**CITY OF PORTLAND, MAINE
DEVELOPMENT REVIEW APPLICATION
PLANNING DEPARTMENT PROCESSING FORM**

3/10/00
Application Date
Milton Street Subdivision
Project Name/Description

Gorrill-Palmer Consulting Engineers, Inc. has received a copy of the memorandum to Rick Knowland from DeLuca-Hoffman Associates, Inc., dated August 24, 1999, regarding comments concerning the above referenced project and has prepared responses to each of their comments. For your convenience, each of his comments is repeated followed by our response.

Gorrill-Palmer Consulting Engineers, Inc. has received a copy of the memorandum to Rick Knowland from Anthony Lombardo P.E., Project Engineer, Public Works Department dated January 3, 2000, regarding comments concerning the above referenced project and has prepared responses to each of their comments. For your convenience, each of his comments is repeated followed by our response.

TITLE:
ROAD PLAN/PROFILE
 For the Completion of
MILTON STREET
 Being a Portion of
WOODFORDS GARDENS
 Portland, Maine

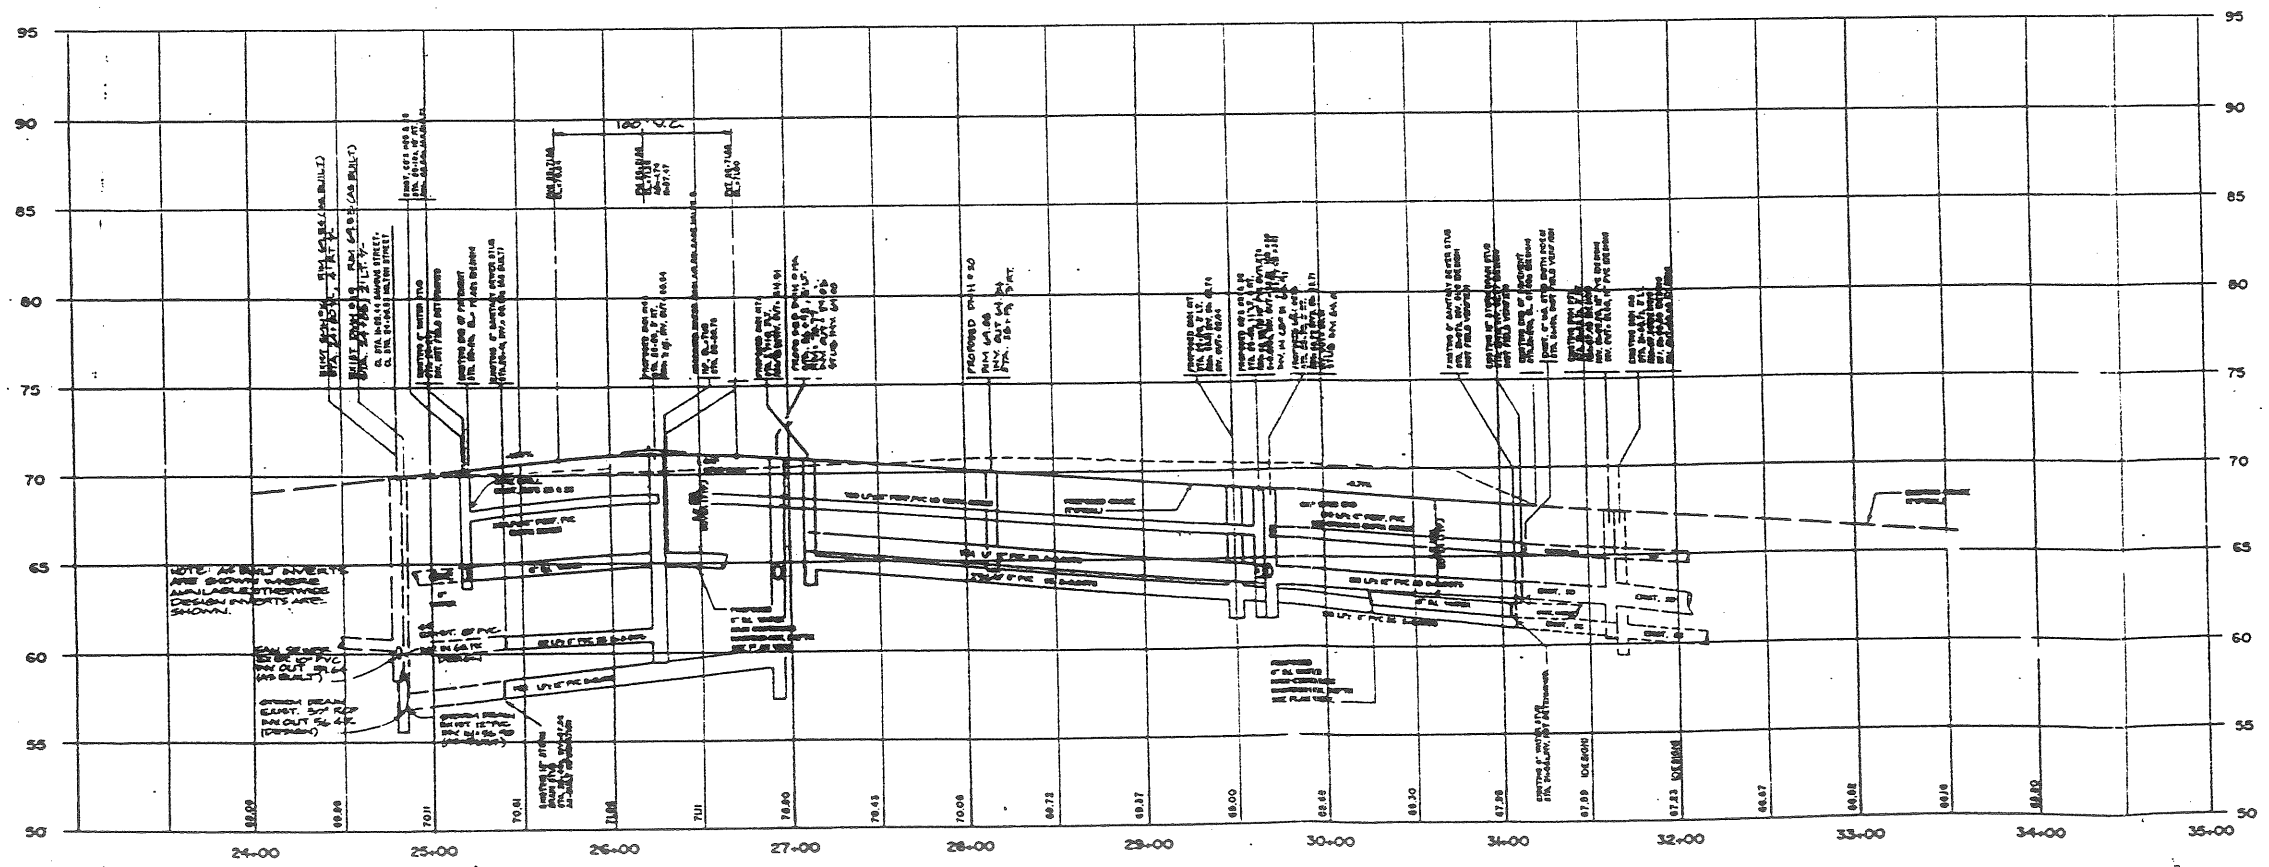
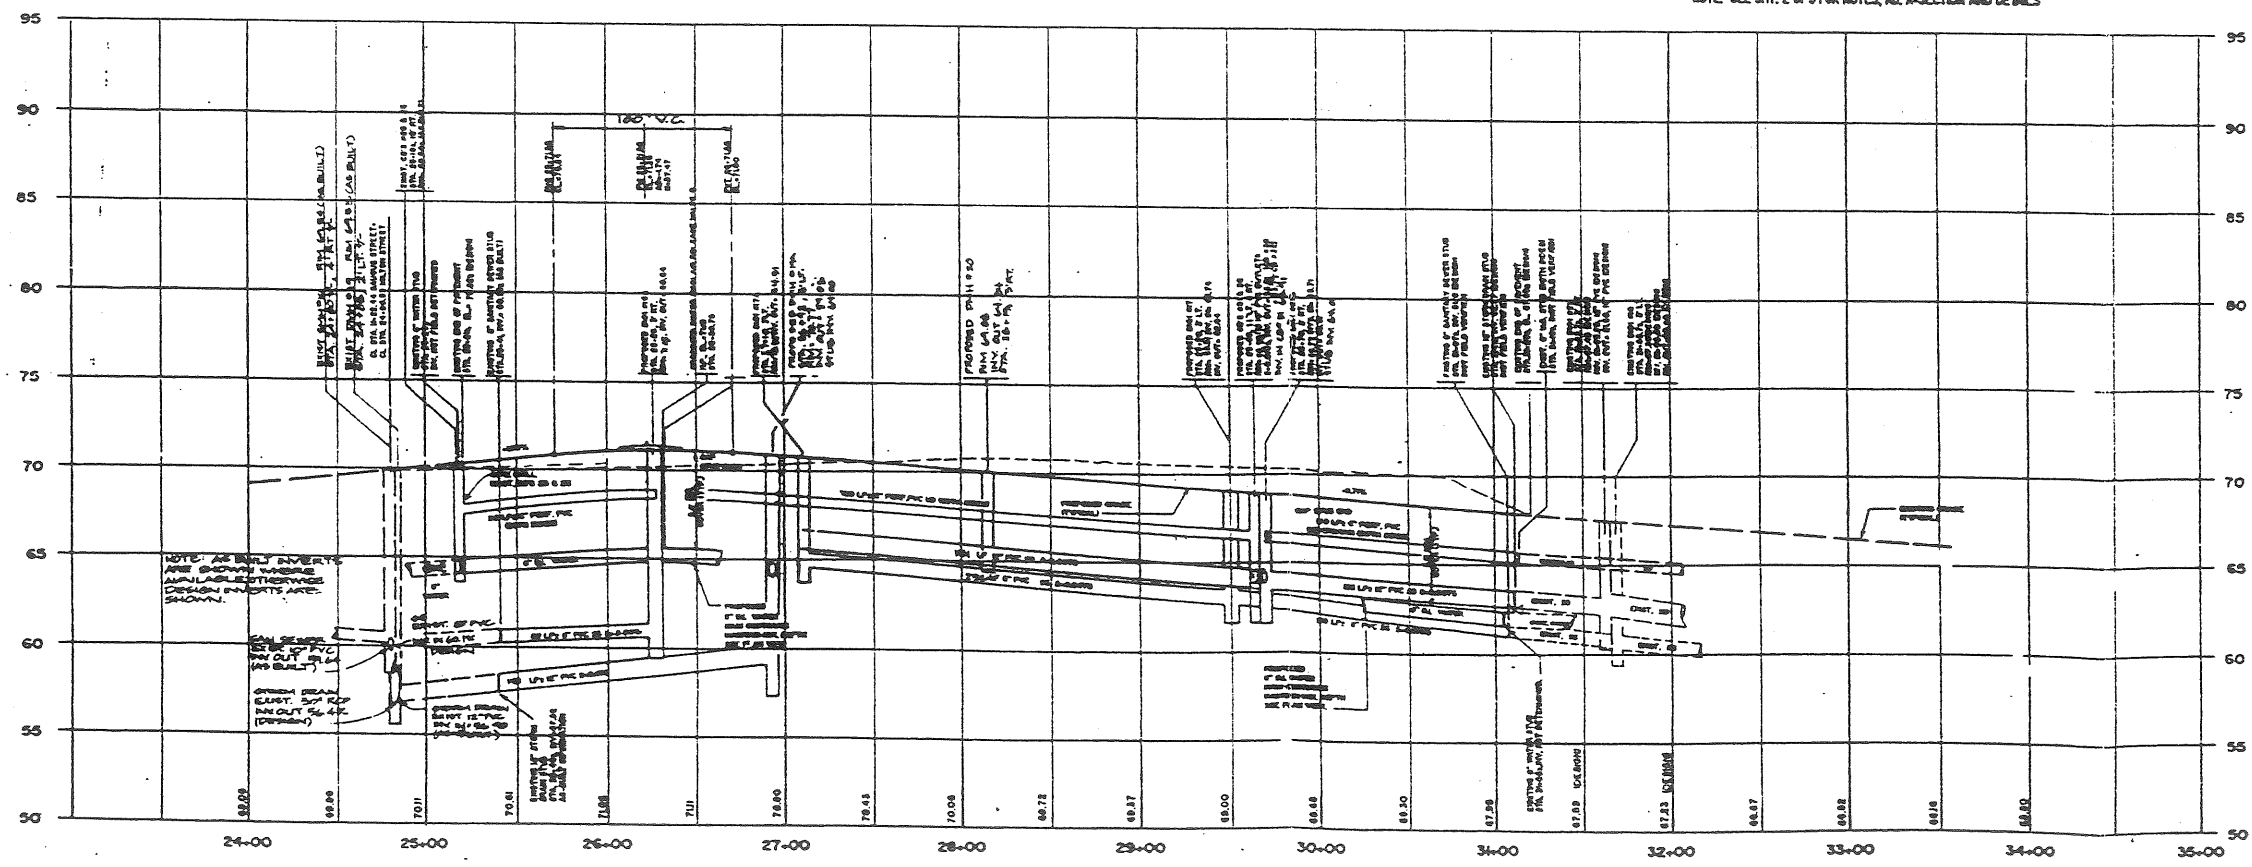
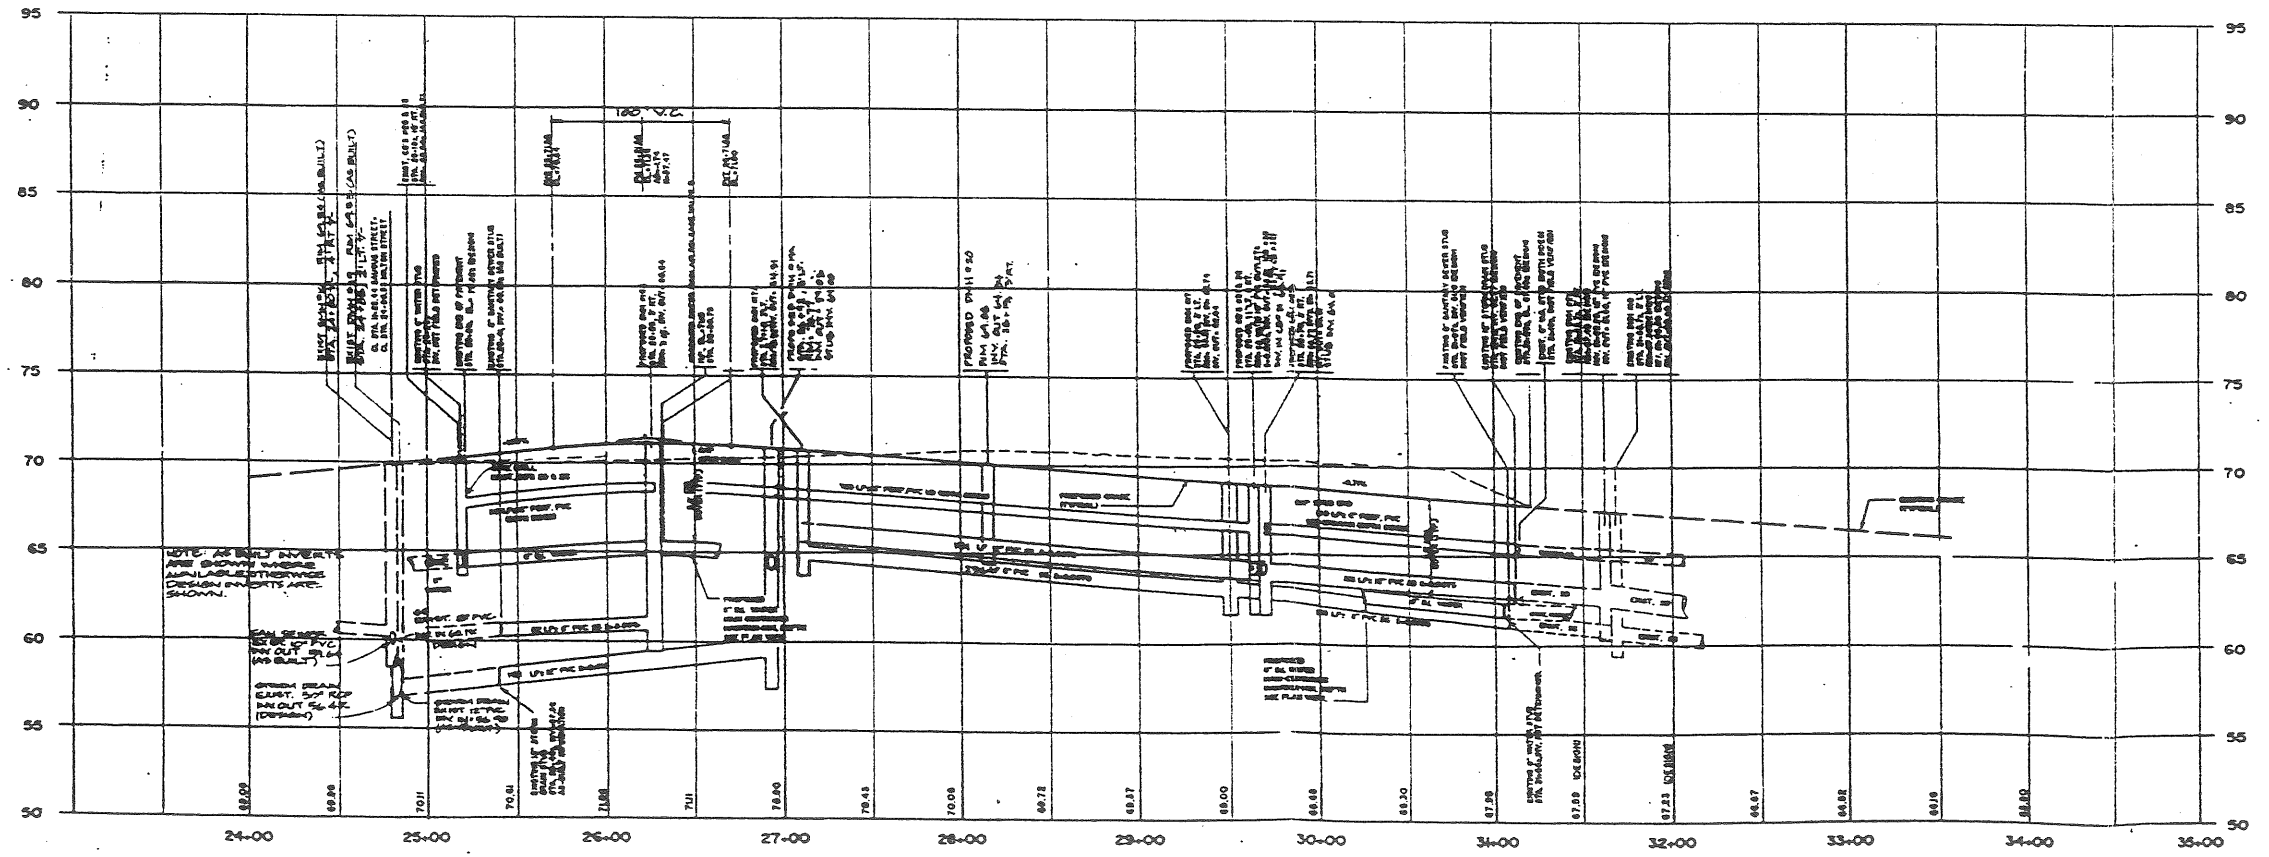
Comment 3 –Technical standards require a street light pole at 120 foot intervals. You are proposing them at 200 foot intervals.

Comment 1 – The “Conceptual Development Plan” and the plan entitled “Road Plan/Profile for the completion of Milton Street” specify conflicting utility information. DMH-19 is labeled DMH-19A on the “Road Plan/Profile”. The “Conceptual Plan” proposes a storm drain connection into DMH-19 from lots 167 & 168. The “Road Plan/Profile” specifies only a stub section of pipe. The “Conceptual Plan” proposes a storm drain connection into CB-31 from Lots 170 & 171. The “Road Plan/Profile”, instead, specifies a 12” diameter storm drain stub towards the center of Lot 171 and not towards the easement proposed between Lots 170 & 171.

Comment 4 – The “Road Plan/Profile” should also specify every storm drain and sanitary service from each proposed house lot. This is extremely useful in avoiding utility crossing conflicts.

Comment 5 – Public Works is requesting the applicant produce a plan and profile that specifies development on both sides of the street and includes all proposed utility installations.

Response –The enclosed full sized Road Plan/Profile for Milton Street has been revised to show 120 foot space intervals for the street light poles.

Response – The “Conceptual Development Plan” has been revised to agree with the “Road Plan/Profile.” The “Road Plan/Profile” has been revised to indicate the entire limit of work for the storm drain system on the adjacent lots

Response – All of the storm drain and sanitary sewer services have been added to the plan view of the “Road Plan/Profile”. Previously, the services were noted for one of the lots and indicated as “typical”.

Response – As discussed with Mr. Lombardo, our office will be revising the “Road Plan/Profile” so that it depicts the construction associated with all of the infrastructure and revising the “Conceptual Development Plan” to depict all of the lot construction. These plans will be delivered to the City on Monday January 10, 2000.
